Access Compliance Report

Public Rights-of-Way

(Curb Ramps)

Intersection ID: 42988	Main Street: UNIVERSITY_CITY_BV	Cross Street: UNIVERSITY_WALK_CR	Location: W
ADA ID: E7B24F8098CF	Ramp Type: Perp	Initial Pass/Fail: Fail	Overall Compliance: No
Severity Score: 25			
Codes/Mitigation Info/Possible Solution		Field Measurements/Component Compliance

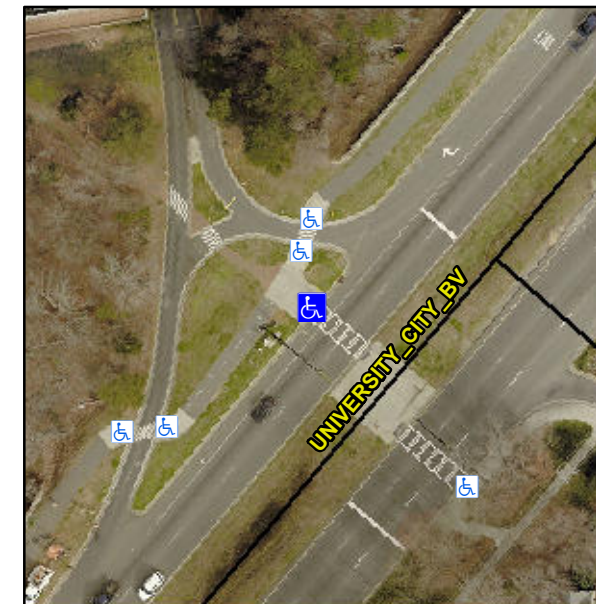
Not Found, R304.2.2

Compliance	Description	Data	Compliance	Description	Data
N/A	Ramp Length (in)	126.0	No	Ramp Slope (%)	13.2
Yes	Ramp Width (in)	99.0	Yes	Ramp XSlope (%)	0.4
N/A	Flare Type LT	N/A	N/A	Flare Type RT	N/A
N/A	Flare Slope LT (%)	N/A	N/A	Flare Slope RT (%)	N/A
N/A	Flare Traversable LT?	N/A	N/A	Flare Traversable RT?	N/A
N/A	Landing Length (in)	N/A	N/A	DWS Provided?	N/A
N/A	Landing Width (in)	N/A	N/A	DWS Contrast?	N/A
N/A	Landing Slope (%)	N/A	N/A	DWS Length (in)	N/A
N/A	Landing X Slope (%)	N/A	N/A	DWS Full Width?	N/A
N/A	Landing Curb? (Y/N)	N/A	N/A	DWS Offset (in)	N/A
N/A	Shared Landing?	N/A			
N/A	Gutter Ponding?	N/A	N/A	Gutter Slope (%)	N/A
N/A	Gutter Lip Ht (in)	N/A	N/A	Gutter X Slope (%)	N/A
N/A	Painted X Walk1?	Yes	N/A	Painted X Walk2?	N/A
	X Walk 1 Direction	To SE		X Walk 2 Direction	N/A
N/A	X Walk 1 Width (in)	111.0	N/A	X Walk 2 Width (in)	N/A
	X Walk 1 Slope (%)	5.8		X Walk 2 Slope (%)	N/A
	X Walk 1 X Slope (%)	0.8		X Walk 2 X Slope (%)	N/A

Remove & Replace Entire Ramp.
